CITY OF NEWTON
Massachusetts

SUBJECT: Consistency Request
Special Permit #59-21, 1092-1098 Chestnut Street

Height

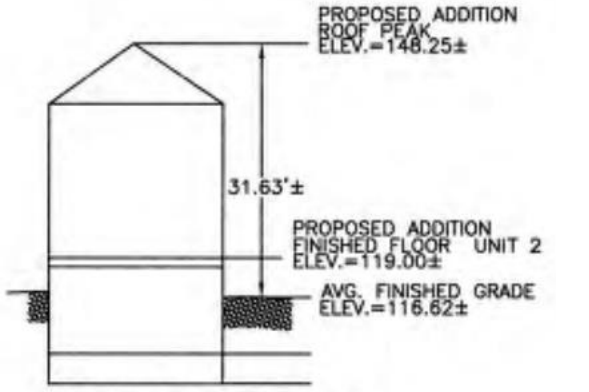
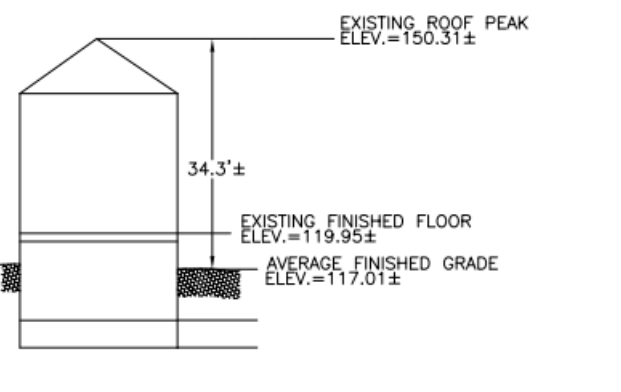
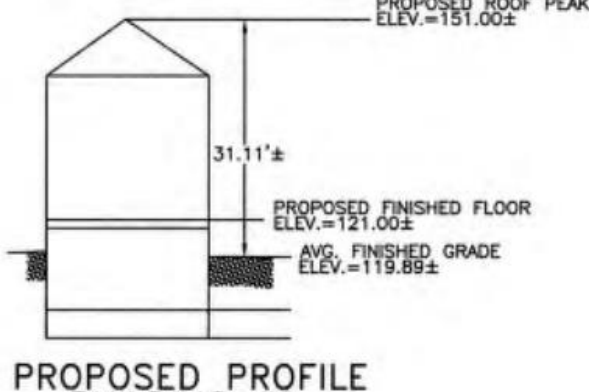
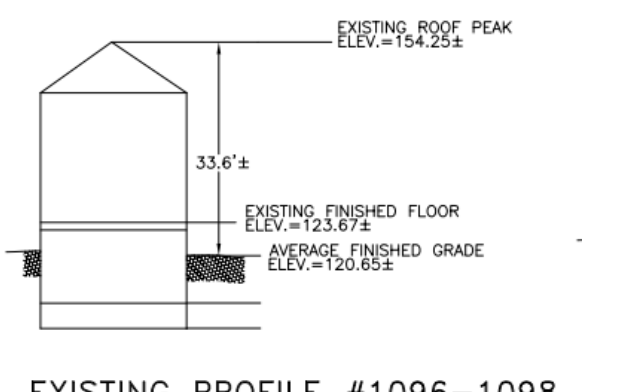
The approved heights are as follows: 31.63' for Building 1 and 31.11' for Building 2 whereas the constructed heights on the As Built plans were 33.3' for Building 1 and 33.6' for Building 2. This represents an increase of 1.67 feet for Building 1 and an increase of 2.5 feet for Building 2. There seems to be a discrepancy for the calculation for Building 2's as built height, the plans show a height of 34.3 feet, however when subtracting the average grade from the peak of the roof, the height comes out to 33.6 feet. The applicant should address this discrepancy at the Land Use Committee meeting. Planning notes that the height was incorrectly shown on the plans at permitting because the height was only measured from the average grade to the peak of the addition. The applicant claims this was in error due to the existing building being taller than the addition and where the height should have been measured to. The Planning Department also notes on the below graphics that the average finished grade is approximately less than a foot higher (approximately 5 inches for Building 1 and approximately 9 inches for Building 2), which is included in this consistency request as shown on the site plans.

Retaining Walls

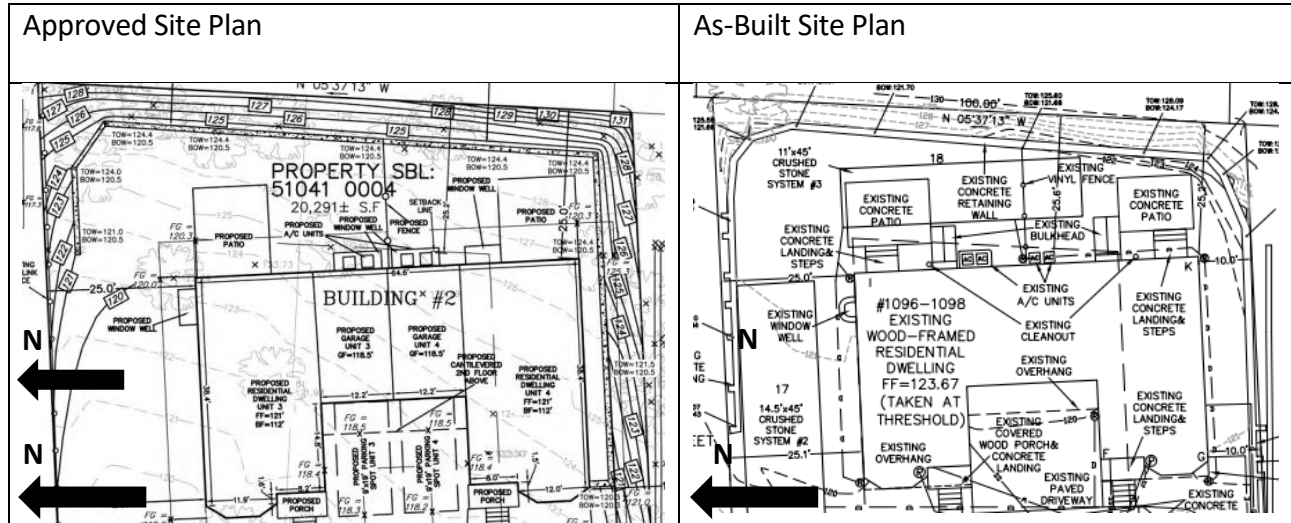
The approved plans show the retaining wall ends along the northern (left) lot line even with the plane of the rear façade of the house, however it extends about 25' longer to the west to the front of Building 2 and is constructed about 5' closer to the lot lines to the north and south, resulting in the walls constructed right on the side property lines, where they were previously set away from. The overall heights of the walls have not changed and are consistent with the approved plans.

Ramp

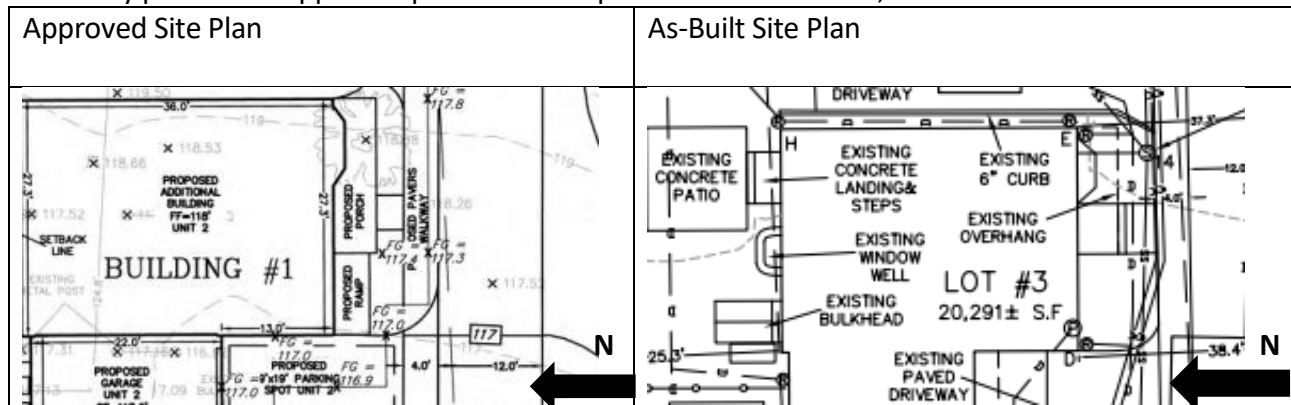
During the public hearing process, the plans were modified to include a ramp outside Unit 2 and were ultimately part of the approved plans. The ramp was not constructed, thus deemed inconsistent.
